C15-2011-0022
ROW-10552799
TP-0110020621

CITY OF AUSTIN
APPLICATION TO BOARD OF ADJUSTMENT
INTERPRETATIONS
PART I: APPLICANT'S STATEMENT
(Please type)

STREET ADDRESS: 1204 W. 9th Street, Austin TX

7.1 Rear set back

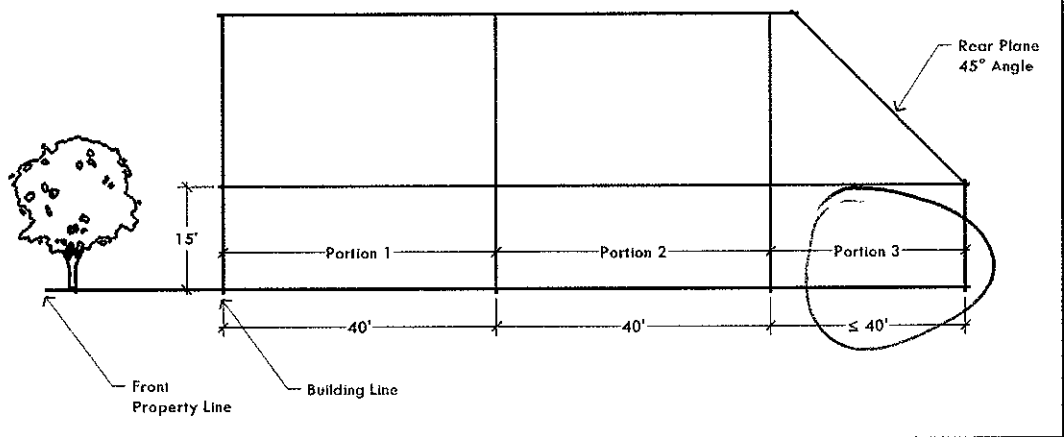
* Intent is to place this Rear Setback at 9 1/2. However, setback averaging was used to calculate the setback - which is not allowed on the rear of a through lot.

SMITH RESIDENCE: SITE PLAN

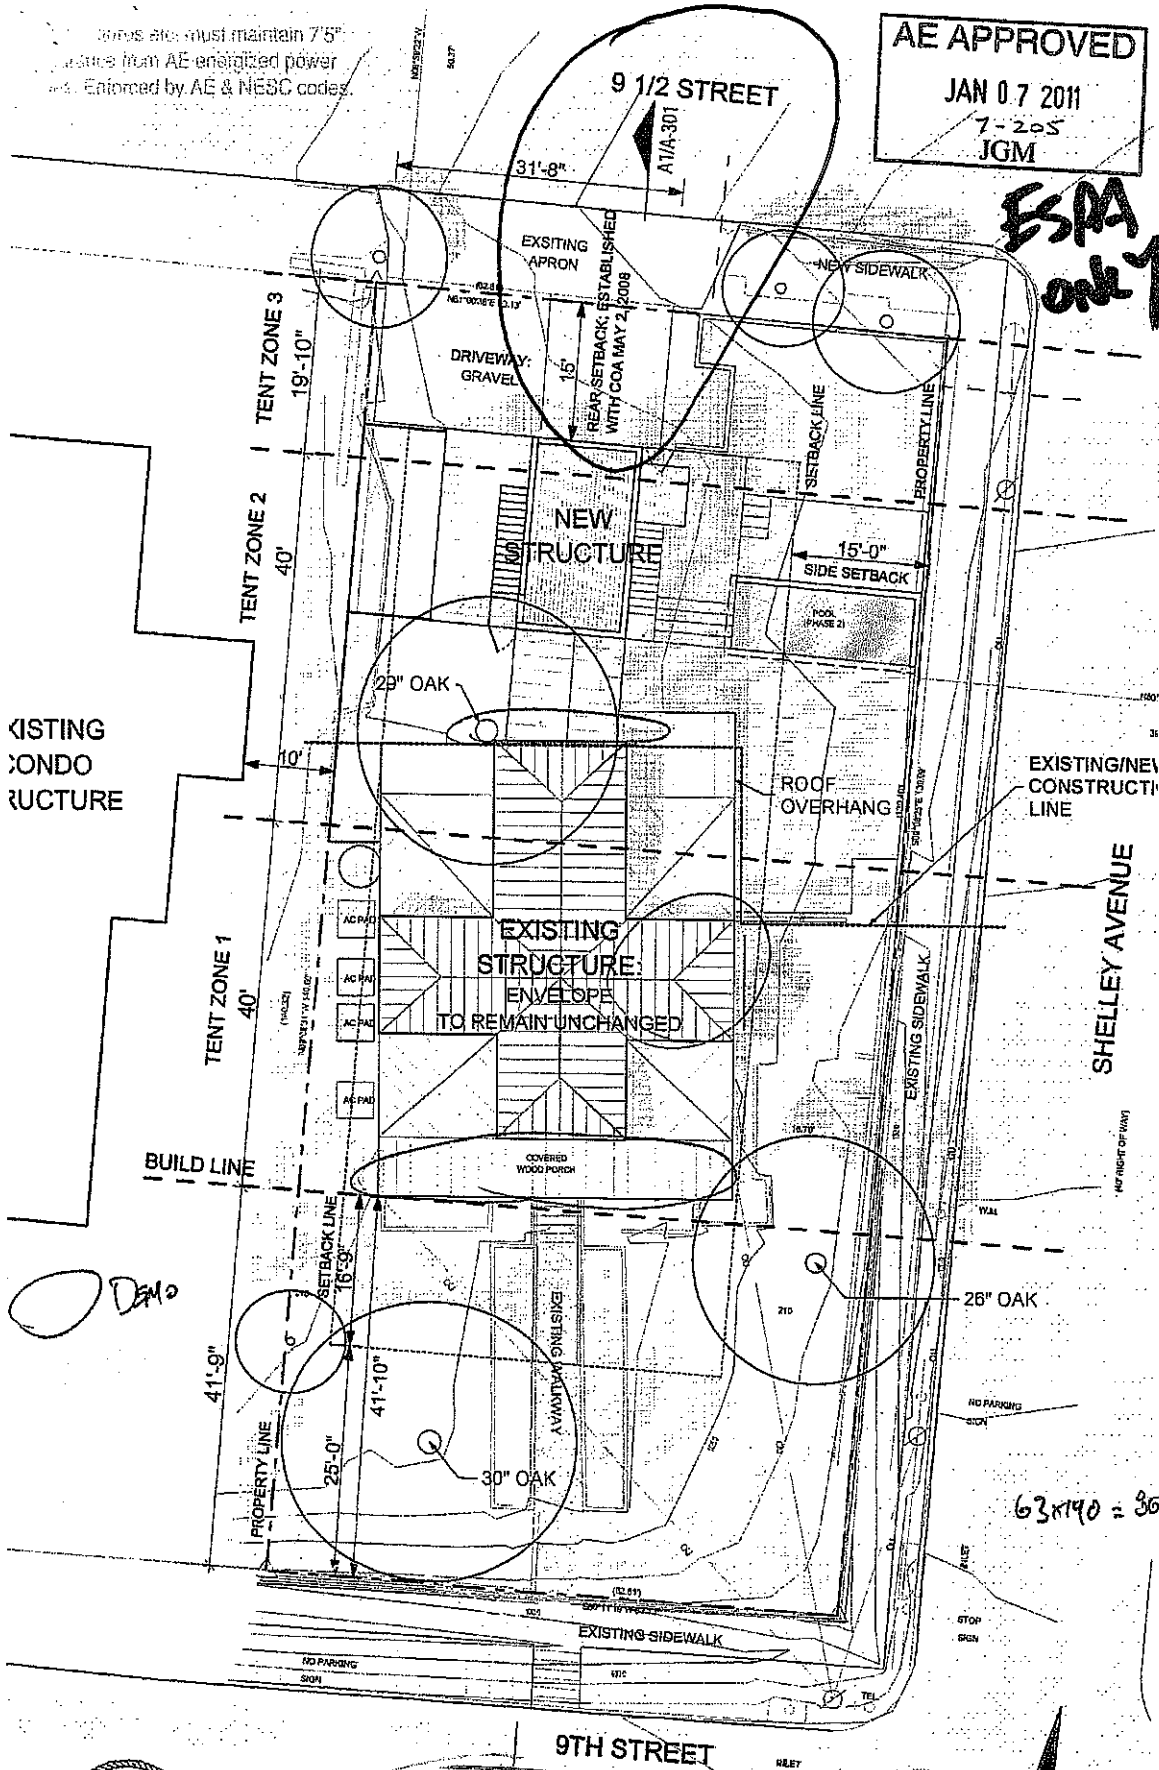
The "rear setback" is clearly marked in the site plan presented at public hearing and included in the Residential Permit application as residing on 9 ½ Street at 15'. The permit #02011-001967 PR was clearly approved with a rear setback of 7' on 9 ½ Street and a the buildable tent was clearly drawn with the rear zone (Portion 3) on 9 ½. (A correction in averaging data has subsequently been submitted along with new drawings, but has only been in response to my appeal. The issue is whether setback averaging is allowed on the rear of a through lot, which is what I believe is happening).

The "rear setback" is clearly marked in the site plan presented at public hearing and included in the Residential Permit application as residing on 9 ½ Street at 15'. The tent zone is drawn with the back of the zone (zone 3) facing 9 ½, even after setback calculations and drawing were submitted. The permit #02011-001967 PR is clearly approved with a "rear setback" of 7' on 9 ½ Street. So, per the definitions above, the site plan and the permit drawings, the REAR LOT LINE

must exist on 9 ½ across from the “rear setback” . There were no site plans, drawings or notes to indicate that the FRONT LOT LINE exists on 9 ½. So, setback averaging was incorrectly applied at the REAR of a through lot, in this case.

Confirm the FRONT LOT LINE is on 9th Street and confirm the REAR LOT LINE is on 9 ½ Street. Apply the correct code from LDC to determine appropriate rear setback on the rear of this through lot on 9/12.
